ECE/TRANS/WP.29/2010/17
18 December 2009

Proposal for Supplement 35 to the 03 series of amendments to Regulation No. 37
(Filament lamps of power-driven vehicles and their trailers)

Submitted by the Working Party on Lighting and Light-Signalling */

CATEGORIES P13W and PW13W

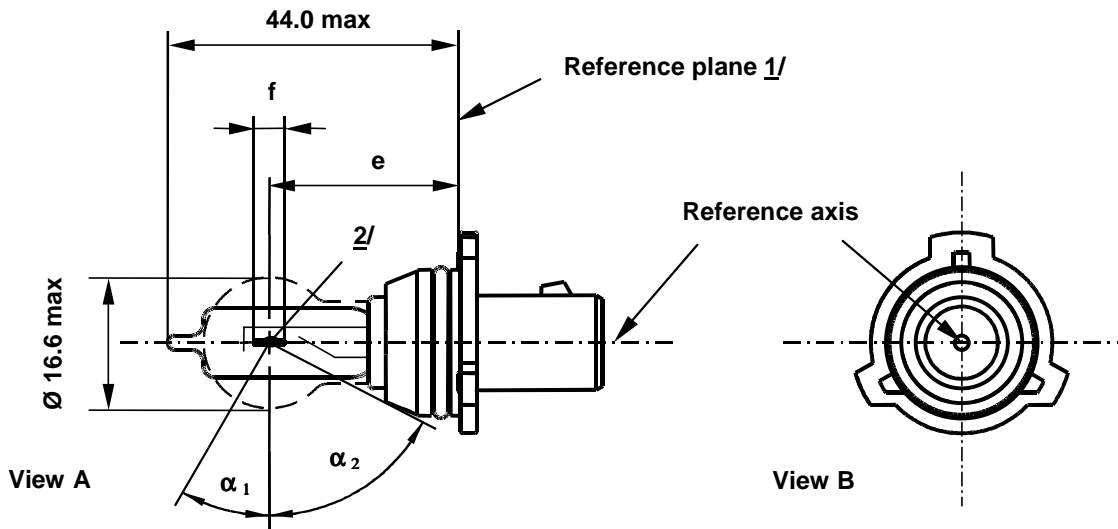
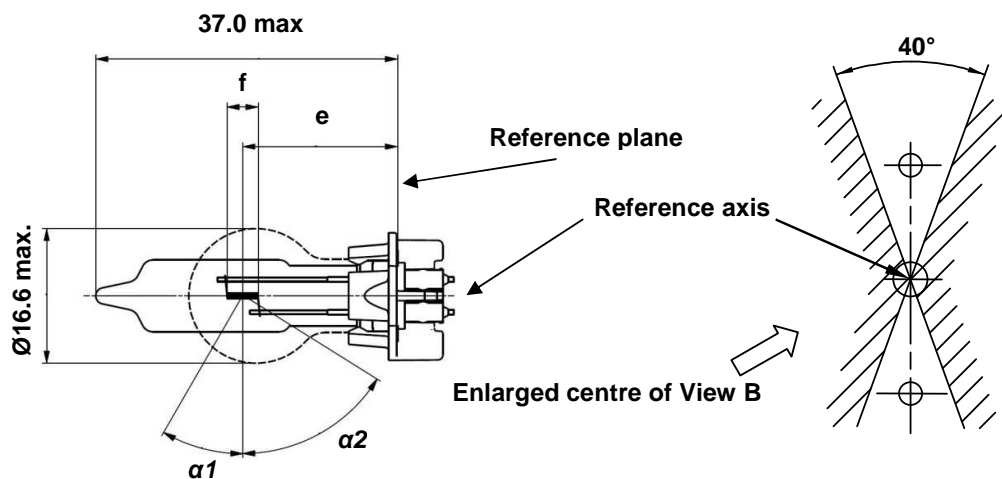
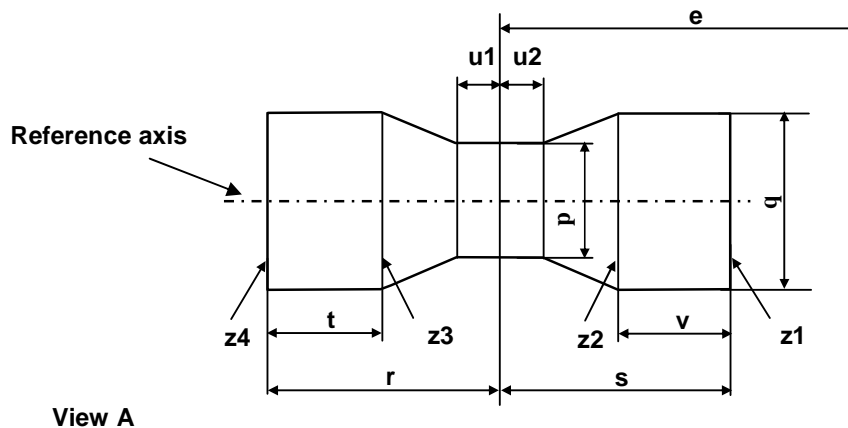
Sheets P13W/1 to P13W/3 (existing), replace by the new sheets P13W/1 to P13W/3, to read (see below):

- 1/ The reference plane is defined by the meeting points of the cap-holder fit.
- 2/ No actual filament diameter restrictions apply but the objective is $d_{max} = 1.0$ mm.
- 3/ No opaque parts other than filament turns shall be located in the shaded area indicated in Figure 2. This applies to the rotational body within the angles $\alpha_1 + \alpha_2$.

Dimensions in mm		Filament lamps of normal production		Standard filament lamp
e	<u>5/</u> P13W	25.0	<u>4/</u>	25.0 ± 0.25
	PW13W	19.25	<u>4/</u>	19.25 ± 0.25
f	<u>5/</u>	4.3	<u>4/</u>	4.3 ± 0.25
α_1	<u>6/</u>	30.0°min.		30.0°min.
α_2	<u>6/</u>	58.0°min.		58.0°min.
P13W	Cap PG18.5d-1	in accordance with IEC Publication 60061 (sheet 7004-147-1)		
PW13W	Cap WP3.3x14.5-7	in accordance with IEC Publication 60061 (sheet 7004-xxx-x)		
ELECTRICAL AND PHOTOMETRIC CHARACTERISTICS				
Rated values	Voltage	V	12	12
	Wattage	W	13	13
Test voltage		V	13.5	13.5
Objective values	Wattage	W	19 max.	19 max.
	Luminous flux	lm	250	
		±	+15% / -20%	
Reference luminous flux at approximately 13.5V				250 lm

- 4/ To be checked by means of a "Box-System"; sheet P13W/3.
- 5/ The ends of the filament are defined as the points where, when the viewing direction is perpendicular to the plane through the filament lead-in wires, the projection of the outside of the end turns crosses the filament axis.
- 6/ No part of the cap beyond the reference plane shall interfere with angle α_2 as shown in Figure 1 on sheet P13W/1. The bulb shall be optically distortion free within the angles $\alpha_1 + \alpha_2$. These requirements apply to the whole bulb circumference.

p	q	u1,u2	r,s	t,v
Filament lamps of normal production	1.7	1.9	0.3	2.6	0.9
Standard filament lamps	1.5	1.7	0.25	2.45	0.6

The ends of the filament as defined on sheet P13W/2, note 4/, shall lie between Z1 and Z2 and between the lines Z3 and Z4.

CATEGORIES PC16W, PCY16W, PCR16W, PW16W, PWY16W and PWR16W

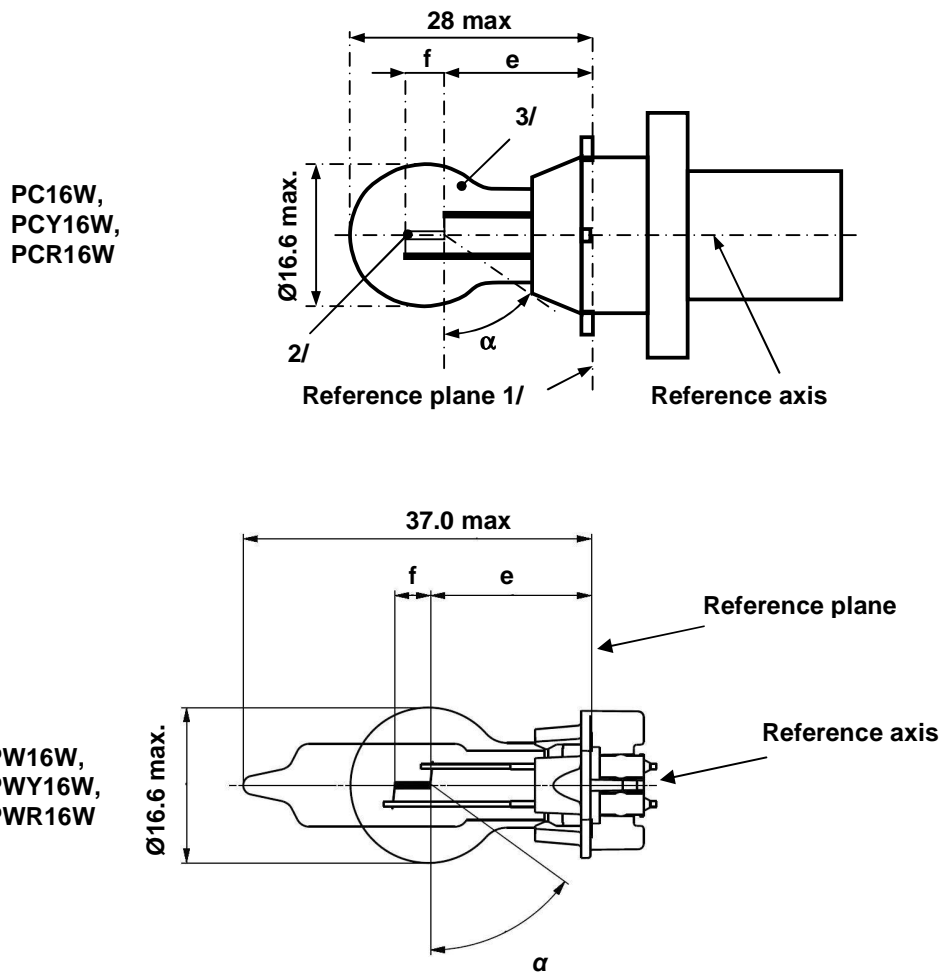
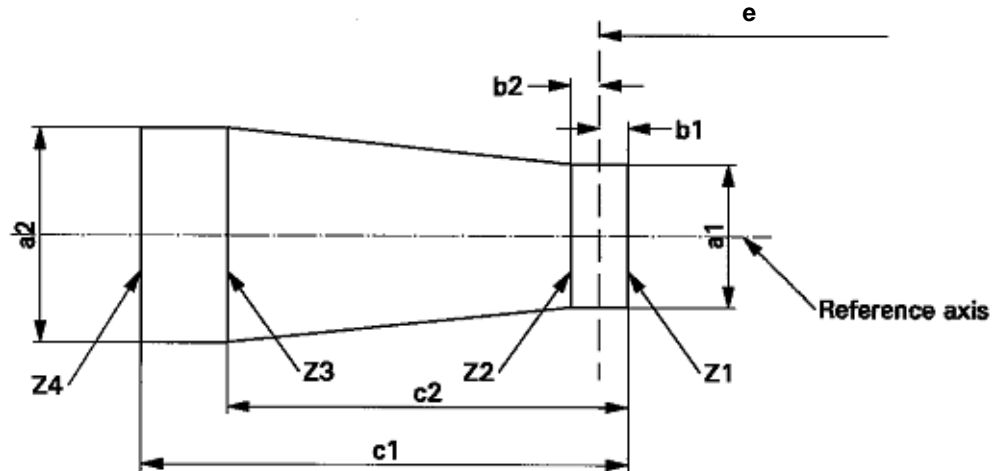
Sheets PC16W/1 to PC16W/3 (existing), replace by the new sheets PC16W/1 to PC16W/3, to read (see below):

- 1/ The reference plane is defined by the meeting points of the cap-holder fit.
- 2/ No actual filament diameter restrictions apply but the objective is $d \text{ max.} = 1.1 \text{ mm}$.
- 3/ The light emitted from normal production lamps shall be white for category PC16W and PW16W; amber for category PCY16W and PWY16W; red for category PCR16W and PWR16W. (see also note 7/).

Dimensions in mm		Filament lamps of normal production			Standard filament lamp	
		min.	nom.	max.	<u>7/</u>	
<u>4/ 5/</u>	PC16W PCY16W PCR16W		18.5		18.5	
	PW16W PWY16W PWR16W		17.1		17.1	
f	<u>4/ 5/</u>		4.0		4.0 ± 0.2	
α	<u>6/</u>	54°			54° min.	
PC16W PCY16W PCR16W	Cap PU20d-1 Cap PU20d-2 Cap PU20d-7	in accordance with IEC Publication 60061 (sheet 7004-157-1)				
PW16W PWY16W PWR16W	Cap WP3.3x14.5-8 Cap WP3.3x14.5-9 Cap WP3.3x14.5-10	in accordance with IEC Publication 60061 (sheet 7004-XXX-X)				
ELECTRICAL AND PHOTOMETRIC CHARACTERISTICS						
Rated values	Volts	12			12	
	Watts	16			16	
Test voltage	Volts	13.5			13.5	
Objective values	Watts	17 max.			17 max.	
	Luminous flux	PC16W PW16W	300 ± 15 %			
		PCY16W PWY16W	180 ± 20 %			
		PCR16W PWR16W	70 ± 20 %			
Reference luminous flux at approximately			13.5 V	White: 300 lm Amber: 180 lm Red: 70 lm

- 4/ The filament position is checked by means of a "Box-System"; sheet PC16W/3.
- 5/ The ends of the filament are defined as the points where, when the viewing direction is perpendicular to the plane through the filament lead-in wires as showed in the drawing on sheet PC16W/1, the projection of the outside of the end turns crosses the filament axis.
- 6/ No part of the cap beyond the reference plane shall interfere with angle α . The bulb shall be optically distortion free within the angle $2\alpha + 180^\circ$.
- 7/ The light emitted from standard filament lamps shall be white for category PC16W and PW16W; white or amber for category PCY16W and PWY16W; white or red for category PCR16W and PWR16W.

PC16W, PCY16W, PCR16W	a1	a2	b1, b2	c1	c2
Filament lamps of normal production	2.9	3.9	0.5	5.2	3.8
Standard filament lamps	1.5	1.7	0.25	4.7	3.8

PW16W, PWY16W and PWR16W	a1	a2	b1, b2	c1	c2
Filament lamps of normal production	2.5	2.5	0.4	5.2	3.8
Standard filament lamps	1.5	1.7	0.25	4.7	3.8

The ends of the filament as defined on sheet PC16W/2, note 5/, shall lie between Z1 and Z2 and between the lines Z3 and Z4.

CATEGORIES P19W, PY19W, PR19W, PS19W, PSY19W, PSR19W, PW19W, PWY19W and PWR19W

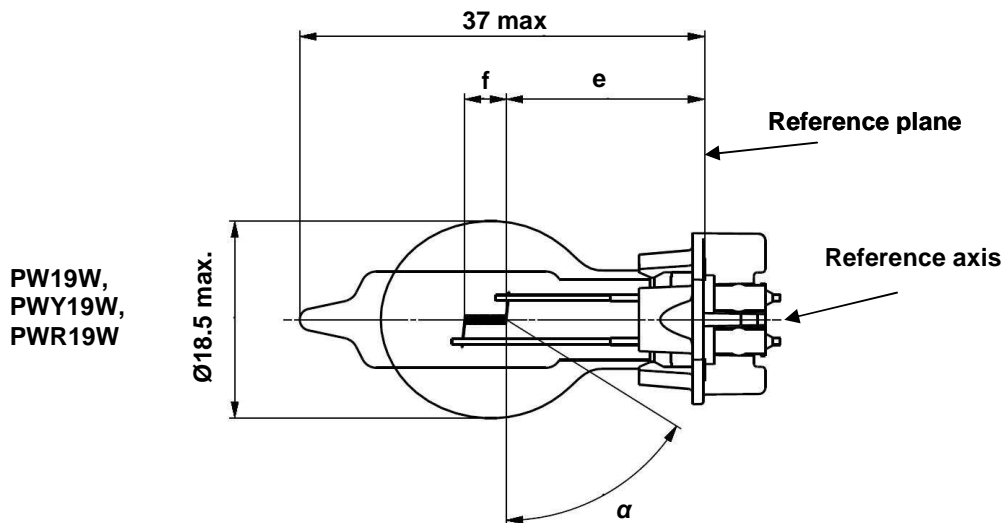
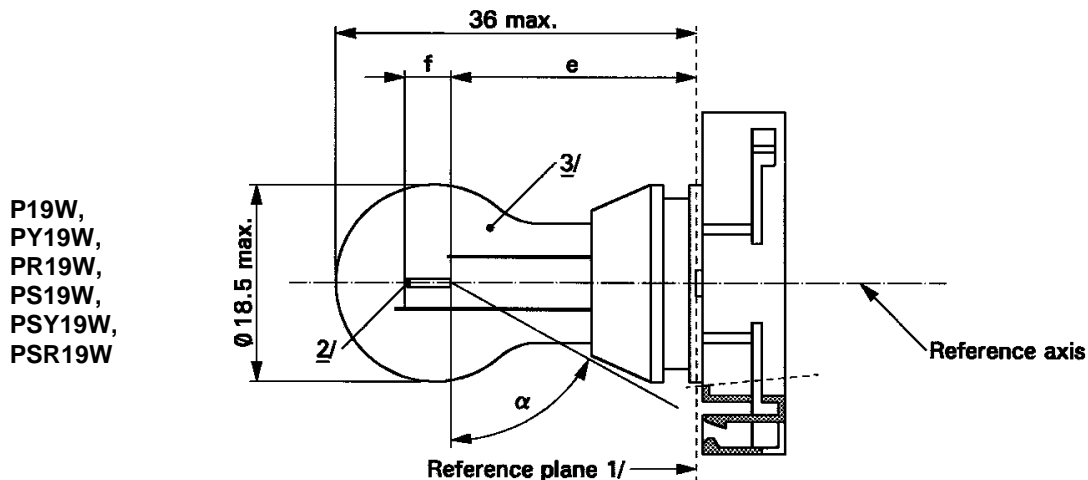
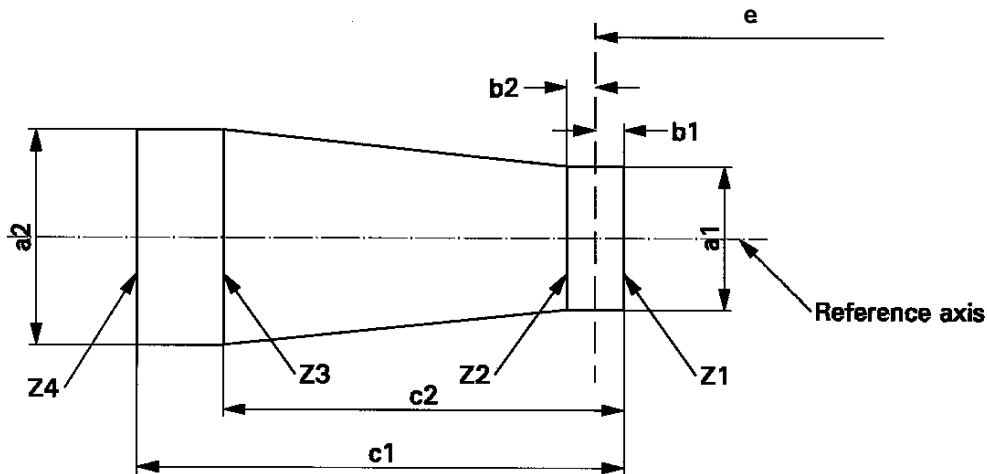
Sheets P19W/1 to P19W/3 (existing), replace by the new sheets P19W/1 to P19W/3, to read (see below):

- 1/ The reference plane is defined by the meeting points of the cap-holder fit.
- 2/ No actual filament diameter restrictions apply but the objective is $d \text{ max.} = 1.1 \text{ mm.}$
- 3/ The light emitted from normal production lamps shall be white for categories P19W, PS19W and PW19W; amber for categories PY19W, PSY19W and PWY19W; red for categories PR19W, PSR19W and PWR19W. (see also note 8/).

Dimensions in mm		Filament lamps of normal production			Standard filament lamp	
		min.	nom.	max.	<u>8/</u>	
<u>e</u>	P19W, PS19W, PY19W, PSY19W, PR19W, PSR19W		24.0		24.0	
	PW19W PWY19W PWR19W		18.1		18.1	
<u>f</u>	<u>5/ 6/</u>		4.0		4.0 ± 0.2	
<u>α</u>	<u>7/</u>	58°			58° min.	
P19W	Cap PGU20-1	in accordance with IEC Publication 60061 (sheet 7004-127-2)				
PY19W	Cap PGU20-2					
PR19W	Cap PGU20-5					
PS19W	Cap PG20-1					
PSY19W	Cap PG20-2					
PSR19W	Cap PG20-5					
PW19W	Cap WP3.3x14.5-1	in accordance with IEC Publication 60061 (sheet 7004-xxx-x)				
PWY19W	Cap WP3.3x14.5-2					
PWR19W	Cap WP3.3x14.5-5					
ELECTRICAL AND PHOTOMETRIC CHARACTERISTICS						
Rated values	Volts	12			12	
	Watts	19			19	
Test voltage	Volts	13.5			13.5	
Objective values	Watts	20 max.			20 max.	
	Luminous flux	P19W PS19W PW19W	350 ± 15 %			
		PY19W PSY19W PWY19W	215 ± 20 %			
		PR19W PSR19W PWR19W	80 ± 20 %			
Reference luminous flux at approximately 13.5 V					White: 350 lm Amber: 215 lm Red: 80 lm

4/ For categories PS19W, PSY19W and PSR19W, dimensions shall be checked with O-ring removed.

5/ The filament position is checked by means of a "Box-System"; sheet P19W/3.

6/ The ends of the filament are defined as the points where, when the viewing direction is perpendicular to the plane through the filament lead-in wires as showed in the drawing on sheet P19W/1, the projection of the outside of the end turns crosses the filament axis.

7/ No part of the cap beyond the reference plane shall interfere with angle α . The bulb shall be optically distortion free within the angle $2\alpha + 180^\circ$.

P19W, PY19W, PR19W, PS19W, PSY19W, PSR19W	a1	a2	b1, b2	c1	c2
Filament lamps of normal production	2.9	3.9	0.5	5.2	3.8
Standard filament lamps	1.5	1.7	0.25	4.7	3.8

PW19W, PWY19W and PWR19W	a1	a2	b1, b2	c1	c2
Filament lamps of normal production	2.5	2.5	0.4	5.2	3.8
Standard filament lamps	1.5	1.7	0.25	4.7	3.8

The ends of the filament as defined on sheet P19W/2, note 6/, shall lie between Z1 and Z2 and between the lines Z3 and Z4.

Sheet P24W/1

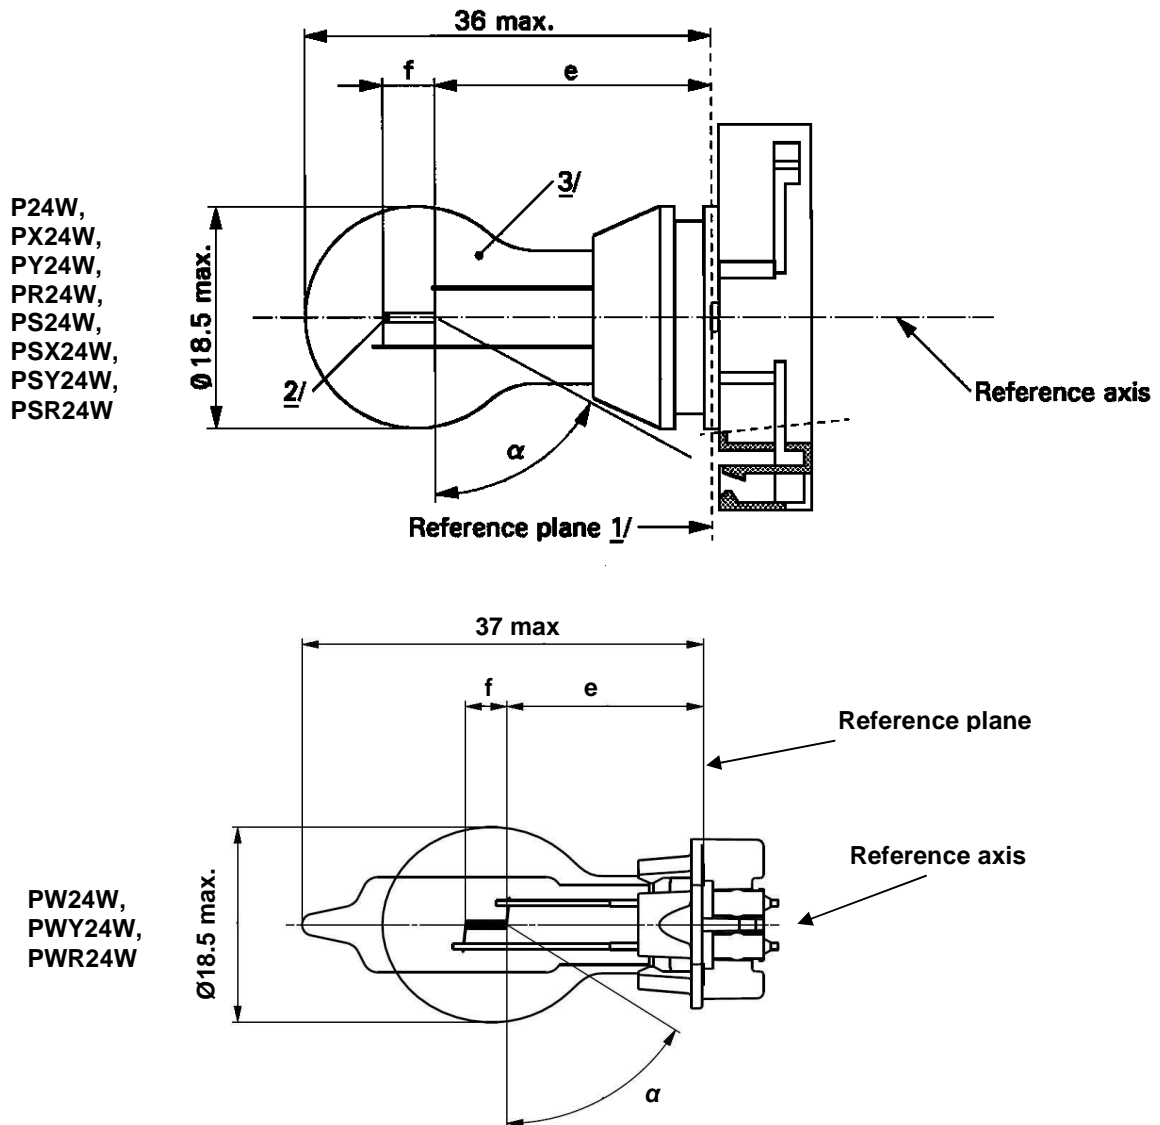
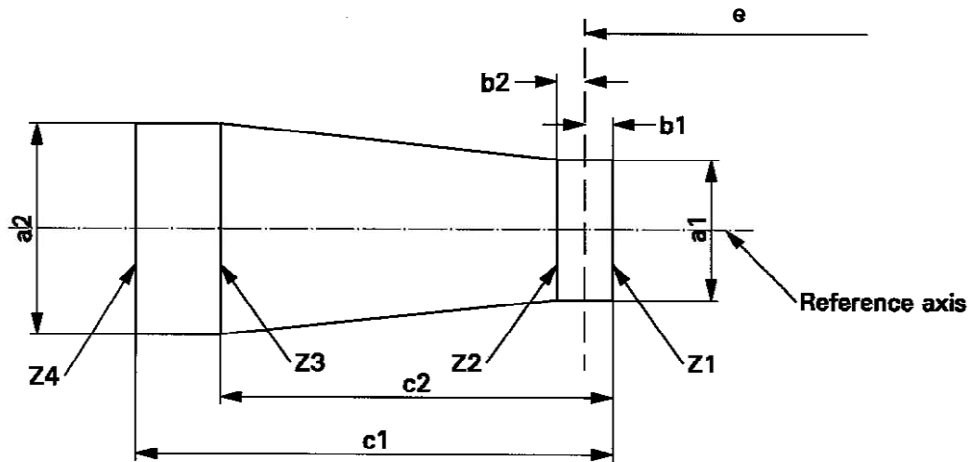
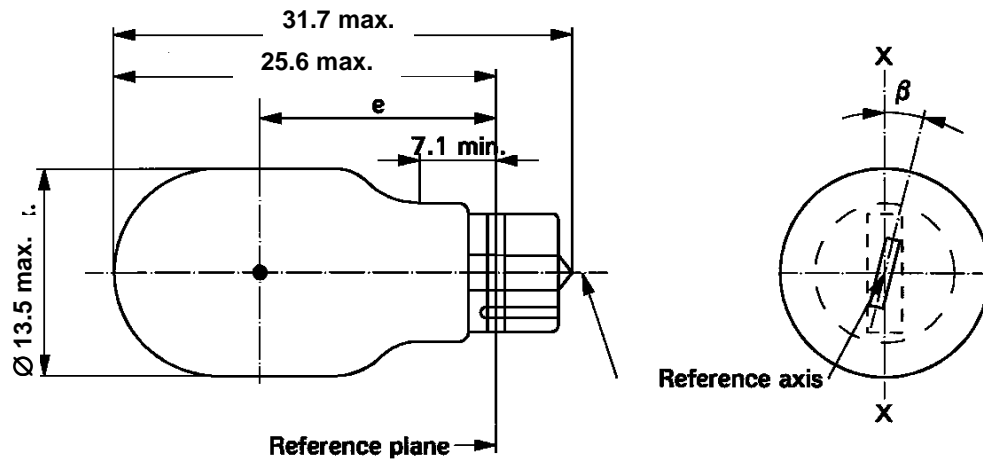
Sheets P24W/1 to P24W/3 (existing), replace by the new sheets P24W/1 to P24W/3, to read (see below):

- 1/ The reference plane is defined by the meeting points of the cap-holder fit.
- 2/ No actual filament diameter restrictions apply but the objective is $d \text{ max.} = 1.1 \text{ mm}$.
- 3/ The light emitted from normal production lamps shall be white for categories P24W, PX24W, PS24W, PSX24W and PW24W; amber for categories PY24W, PSY24W and PWY24W; red for categories PR24W, PSR24W and PWR24W. (See also note 8/)

Dimensions in mm		4/	Filament lamps of normal production			Standard filament lamp
			min.	nom.	max.	8/
e	5/ 6/	P24W, PY24W, PR24W, PS24W, PSY24W, PSR24W, PX24W, PSX24W		24.0		24.0
		PW24W, PWY24W, PWR24W		18.1		18.1
f	5/,6/	P24W, PY24W, PR24W, PS24W, PSY24W, PSR24W, PW24W, PWY24W, PWR24W		4.0		4.0
		PX24W, PSX24W		4.2		4.2
α		7/	58.0 °			58.0° min.
P24W	Cap PGU20-3	in accordance with IEC Publication 60061 (sheet 7004-127-2)				
PX24W	Cap PGU20-7					
PY24W	Cap PGU20-4					
PR24W	Cap PGU20-6					
PS24W	Cap PG20-3					
PSX24W	Cap PG20-7					
PSY24W	Cap PG20-4					
PSR24W	Cap PG20-6	in accordance with IEC Publication 60061 (sheet 7004-XXX-X)				
PW24W	Cap WP3.3x14.5-3					
PWY24W	Cap WP3.3x14.5-4					
PWR24W	Cap WP3.3x14.5-6					
ELECTRICAL AND PHOTOMETRIC CHARACTERISTICS						
Rated values	Volts		12		12	
	Watts		24		24	
Test voltage	Volts		13.5		13.5	
Objective values	Watts		25 max.		25 max.	
	Luminous Flux	P24W PS24W PW24W	500 +10/-20 %

- 4/ For categories PS24W, PSX24W, PSY24W and PSR24W, dimensions shall be checked with O-ring removed.
- 5/ The filament position is checked by means of a "box-system"; sheet P24W/3.
- 6/ The ends of the filament are defined as the points where, when the viewing direction is perpendicular to the plane through the filament lead-in wires as showed in the drawing on sheet P24W/1, the projection of the outside of the end turns crosses the filament axis.
- 7/ No part of the cap beyond the reference plane shall interfere with angle α. The bulb shall be optically distortion free within the angle 2α + 180°.
- 8/ The light emitted from standard filament lamps shall be white for categories P24W, PX24W, PS24W, PSX24W and PW24W; white or amber for categories PY24W, PSY24W and PWY24W; white or red for categories PR24W, PSR24W and PWR24W.

P24W, PY24W, PR24W, PS24W, PSY24W, PSR24W	a1	a2	b1, b2	c1	c2
Filament lamps of normal production	2.9	3.9	0.5	5.2	3.8
Standard filament lamps	1.5	1.7	0.25	4.7	3.8

PW24W, PWY24W, PWR24W	a1	a2	b1, b2	c1	c2
Filament lamps of normal production	2.5	2.5	0.4	5.0	3.8
Standard filament lamps	1.5	1.7	0.25	4.7	3.8

PX24W, PSX24W	a1	a2	b1, b2	c1	c2
Filament lamps of normal production	1.9	1.9	0.35	5.0	4.0
Standard filament lamps	1.5	1.5	0.25	4.7	4.0

The ends of the filament as defined on sheet P24W/2, note 6/, shall lie between Z1 and Z2 and between the lines Z3 and Z4.

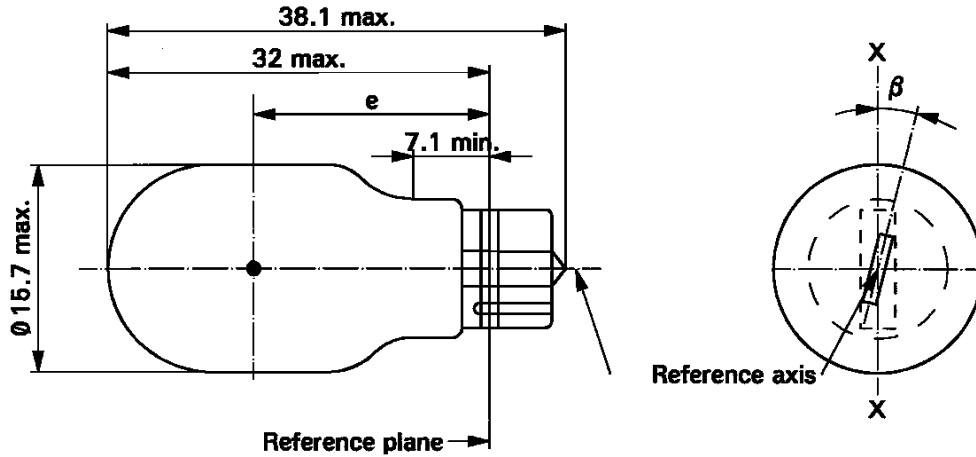
Replace sheet W16W /1, by a new sheet, to read: (see next pages).

Dimensions in mm		Filament lamps of normal production			Standard filament lamp
		min.	nom.	max.	
e		18.3	20.6	22.9	20.6 ± 0.3
Lateral deviation	^{1/}			1.0	0.5 max.
β		-15°	0°	+ 15°	0° ± 5°
Cap W2.1x9.5d in accordance with IEC Publication 60061 (sheet 7004-91-3)					
ELECTRICAL AND PHOTOMETRIC CHARACTERISTICS					
Rated values	Volts		12		12
	Watts		16		16
Test voltage	Volts		13.5		13.5
Objective values	Watts		21.35 max.		21.35 max.
	Luminous flux	White	310 ± 20 %		
		Amber	190 ± 20 %		
Reference luminous flux at approximately 13.5 V:					White: 310 lm
					Amber: 190 lm

^{1/} Maximum lateral deviation of filament centre from two mutually perpendicular planes both containing the reference axis and one containing axis X-X."
